Determination 2012/057

Regarding the issuing of a code compliance certificate for a house with a log fire installed at 566 Tunakino Valley Road, Rai Valley, Marlborough

Figure 1: Chimney terms and dimensions

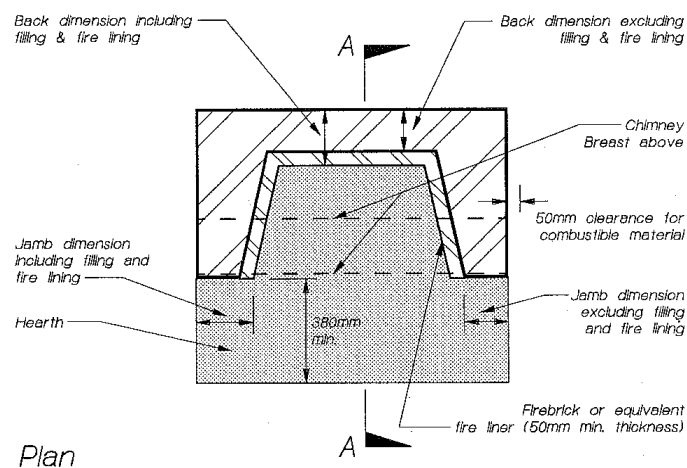
- 7.2.8 I also note that a hearth defines an area where combustible material should not be placed. Combustible material may well be placed up against a hearth by an owner with the reasonable expectation that it will be safe. Figure 1 of C1/AS1 shows a hearth projecting 380mm from an open fireplace; and the owners may well wish to take this more conservative approach by removing the timber trim and lino to this distance from the grate.
